Objections to Proposed Modifications to Rozelle Interchange (Crescent Overpass)

M4-M5 Link Rozelle Interchange

Figure 3 - Fastest route to the city

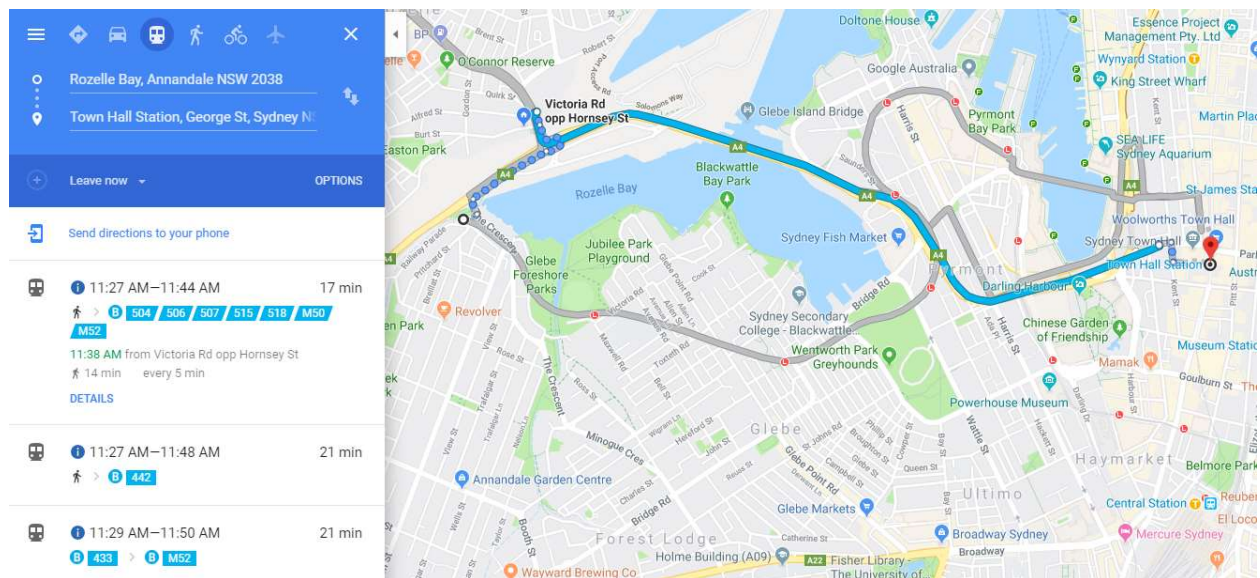
In public consultation meetings, the project team has justified the proposed design by arguing that the GreenLink bridge will be heavily used as it links people to the public transport of the light rail. While the inner west light rail route is certainly popular (usage figures attest to this) it is not a heavily used public transport mode in this part of Sydney. In fact, if you are standing at the light rail, it is considerably faster to walk to Victoria Rd and catch any one of the express buses to the city. These buses also take you to the heart of the CBD and major employment centres, making this the far more utilized route.
